Awel y Môr Offshore Wind Farm

Category 5: Reports

Report 8.2, Annex 2: Evidence Plan Report Appendices Part 2 (D to F)

Figure 1: Noise contours in relation to sandeel spawning grounds.

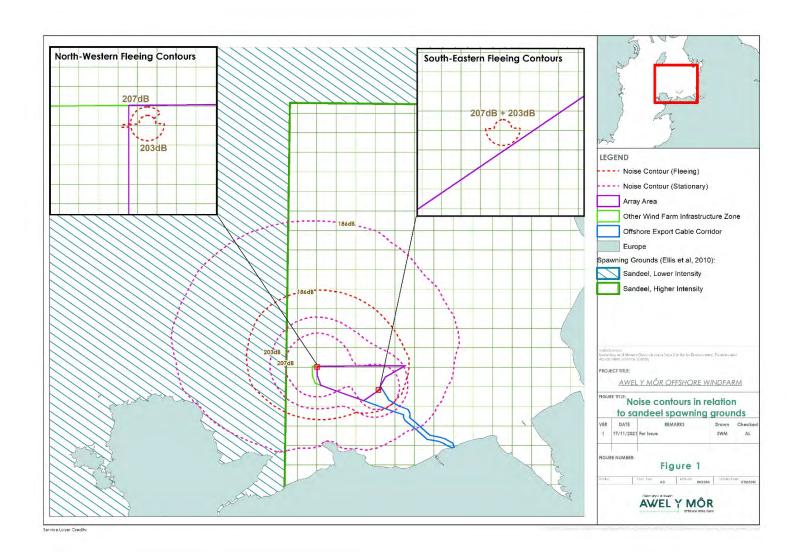
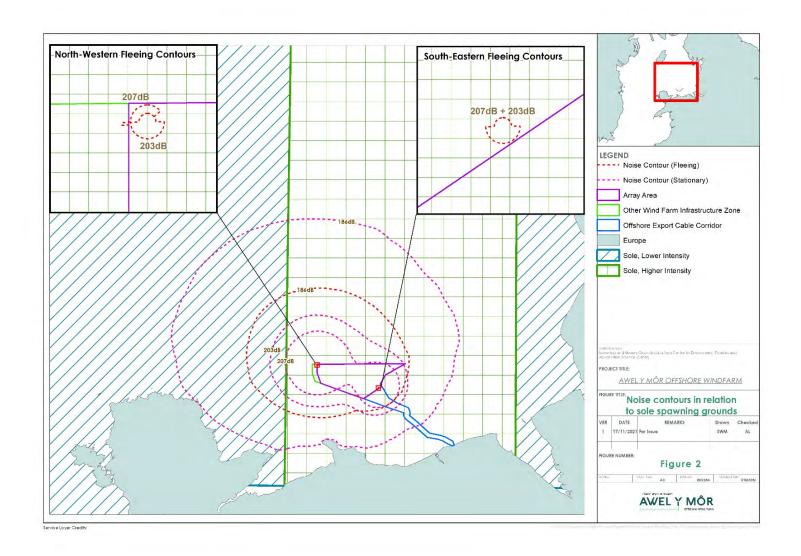
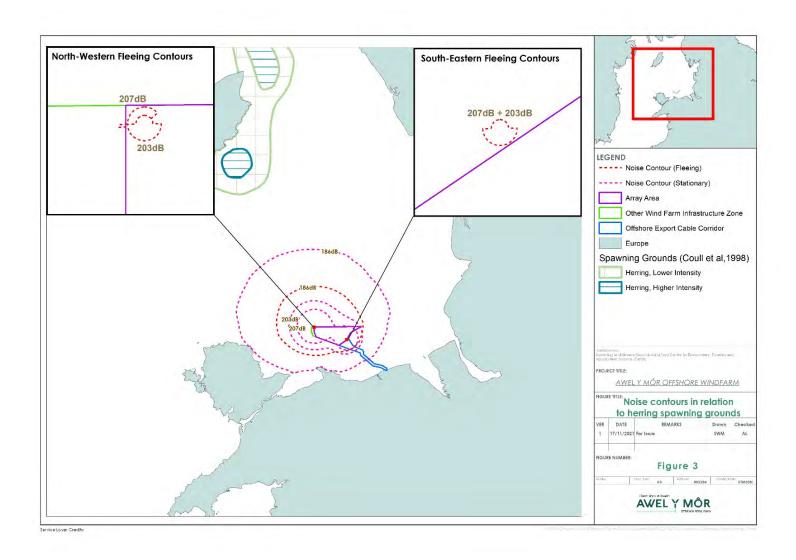
- Following their statutory review of the fish and shellfish ecology assessment presented in the Preliminary Environmental Information Report (PEIR), Natural Resources Wales (NRW) requested clarification on the spawning potential assessments on key receptors (receptors with spawning grounds across the site, with the potential to be sensitive to noise). The full comment from NRW is presented in Table 1 below.

- 13 The modelled noise outputs and their spatial overlaps with spawning grounds are presented in Figure 1, Figure 2 and Figure 3.
- 14 For herring, there is no overlap of any of the noise contours with the Isle of Man spawning ground (see Figure 3), and therefore it can be concluded with confidence that there is no meaningful effect-receptor pathway that could lead to a significant effect on herring spawning from noise impacts. Herring are therefore not considered any further in the assessment of spawning potential within this clarification note.
